Agenda Item # 15

SUB-003758-2026

SpringHill Villas Subdivision

SPRINGHILL VILLAS SUBDIVISION

DETAIL SITE PLAN

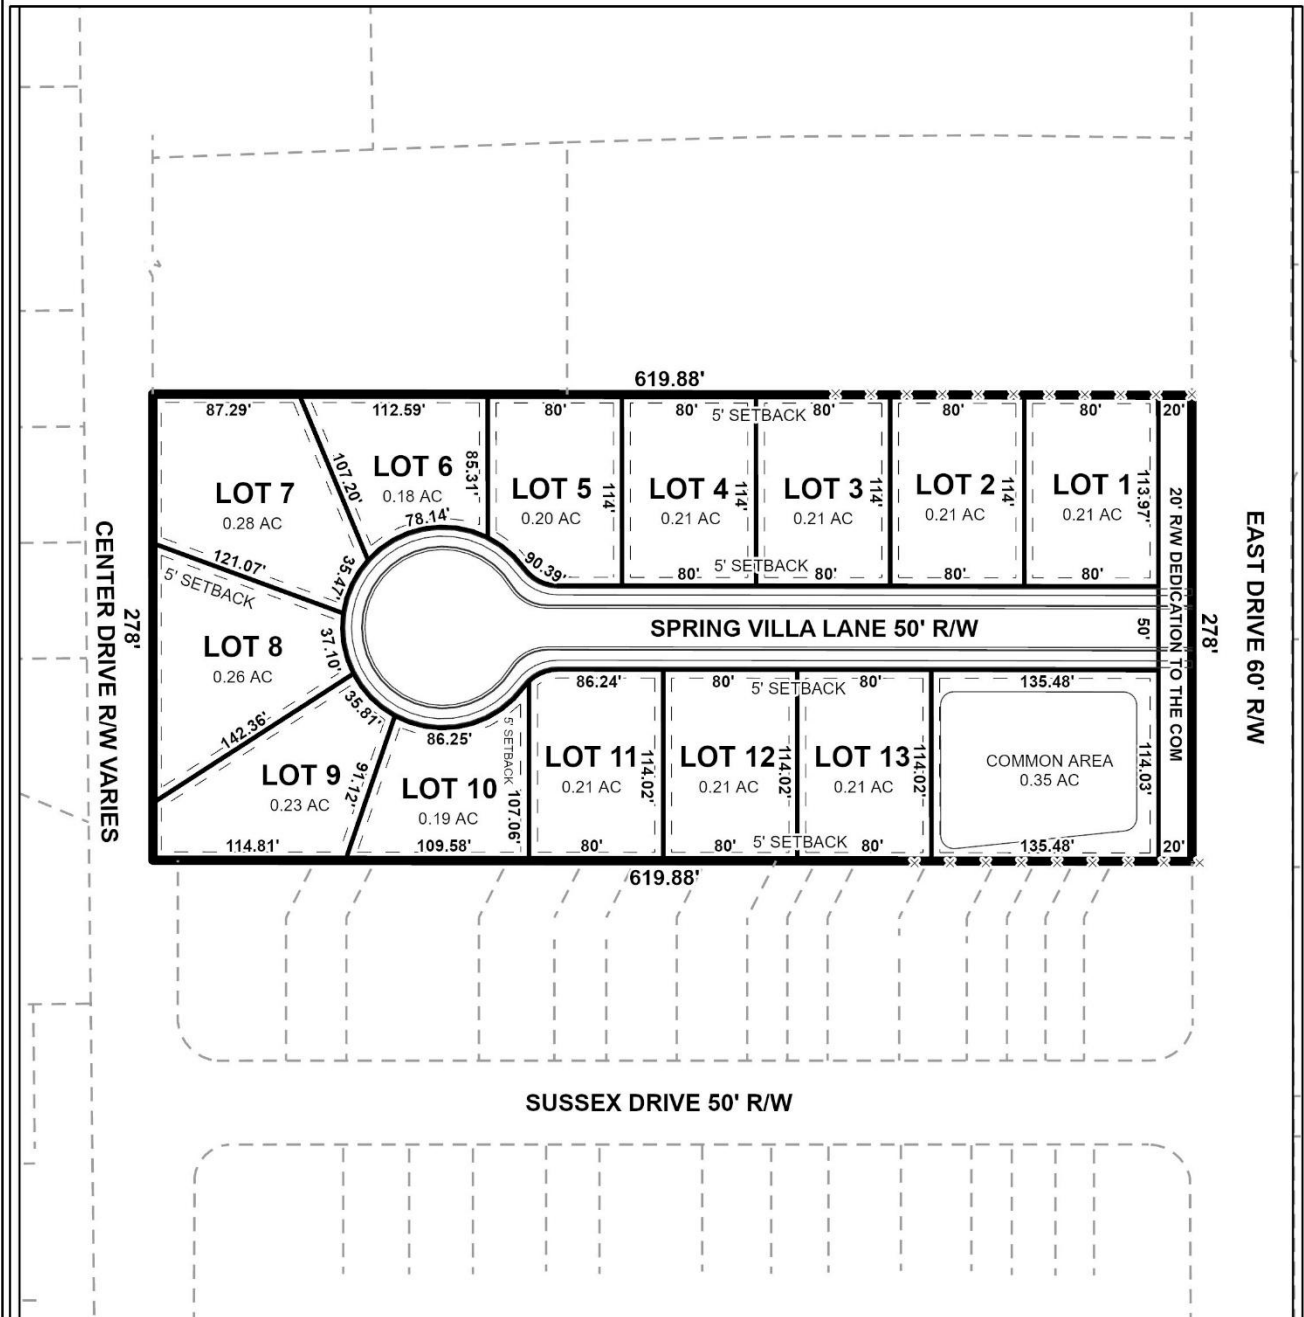
- A. Provide all of the required information on the SUBDIVISION PLAT (i.e. signature blocks, signatures, certification statements, written legal description, required notes, legend, scale, bearings and distances) that is required by the current Alabama State Board of Licensure for Professional Engineers and Land Surveyors.

- B. Remove the Mobile County Engineering Department note. This proposed subdivision is located within the city limits. The County Engineering Dept. no longer reviews/comments on subdivision plats within the municipal limits of the City of Mobile.

- C. Add legible street names to the vicinity map. The vicinity map needs to zoom into the site more than shown.
- D. Dedicate the corner radius (25' minimum or as approved by the City Engineer and Traffic Engineer) at the southeast corner of LOT 1 and the northeast corner of the Common Area to the City of Mobile and list the amount of dedicated acreage in SF and Acres.

- E. Provide a note stating that the required stormwater detention for the LOTS will be provided in a common detention pond in the COMMON AREA.
- F. Add a signature block for the Planning Commission, Traffic Engineer, and City Engineer.

- G. Add a note - As shown on the 1984 aerial photo The subdivision will receive 6,500 SF of historical credit of existing (1984) impervious area and share the 8,000 SF credit provided to the two (2) original SF residential lot towards stormwater detention requirement per Mobile City Code, Chapter 17, Storm Water Management and Flood Control). Stormwater detention will be required for any additional impervious area that exceeds the allowable credit for the entire subdivision (LOTS 1 – 13).

- H. Add a note that the proposed roadway and stormwater improvements shall be complete and approved prior to issuing any residential construction permits.

- I. Retain GENERAL NOTES #4 - #8.
- J. Delete GENERAL NOTES #13 - #15.
- K. Add a note - The proposed road shall be constructed in accordance with current Engineering Department policy letters and design criteria. Provide the as-built certification form, test reports, etc. and as-built plans for the proposed infrastructure prior to providing a copy of the FINAL PLAT to the Engineering Dept. for FINAL PLAT review.

- L. Add a note - The street must be submitted for acceptance by the Mobile City Council prior to submitting the Final Plat for City Engineer signature.

The subject site abuts East Drive, a minor street with curb and gutter. The preliminary plat depicts a compliant right-of-way width of 60 feet, making no dedication necessary. It should be noted that the plat submitted depicts a 20-foot strip along East Drive as being dedicated to the City, but this is not required. As such, the Final Plat should be revised to not include dedication to East Drive's right-of-way.

The plat submitted depicts thirteen (13) proposed lots, with a common area, that are to be accessed by a new public right-of-way, proposed to be named Spring Villa Lane. The plat depicts Spring Villa Lane as having a 50-foot-wide right-of-way, which is compliant for a street with curb and gutter. There is also a compliant cul-de-sac at the end of the street.

It should be noted that the proposed Lots 7, 8, and 9 are less than the minimum required width of 60 feet. As such, if approved, Section 6.C.2.(b)(2) of the Subdivision Regulations must be waived.

Per Section 6.C.7. of the Subdivision Regulations, double frontage lots, such as the proposed Lot 1 and the Common Area should be limited to one (1) street for access. As such, if approved, a waiver of Section 6.C.7. of the Subdivision Regulations will be required, and a note should be placed on the Final Plat stating that Lot 1 and the Common Area are denied direct access to East Drive.

The UDC requires newly platted R-1 Suburban lots to have a 25-foot front setback. The preliminary plat submitted does not depict front setbacks. If approved, the Final Plat should be revised to depict a 25-foot setback along both East Drive and Spring Villa Lane.

1. Removal of the proposed dedication of 20 feet along East Drive;
2. Placement of a note on the plat stating that Lot 1 and the Common Area are denied direct access to East Drive;

3. Placement of a note on the Final Plat stating that Lot 1 and the Common Area are denied direct access to East Drive;
4. Retention of lot sizes in square feet and acres, or provision of a table on the Final Plat with the same information;

5. Retention of the Common Area size in square feet and acres, or provision of a table on the Final Plat with the same information;
6. Placement of a note on the revised plat stating that the maintenance of all common areas is the responsibility of the property owner(s) and not the City of Mobile, in compliance with Section 2.A. of the Subdivision Regulations;

7. Revision of the plat to illustrate a 25-foot front setback for all lots and the Common Area along both East Drive and Spring Villa Lane;
8. Compliance with all Engineering comments noted in this staff report;
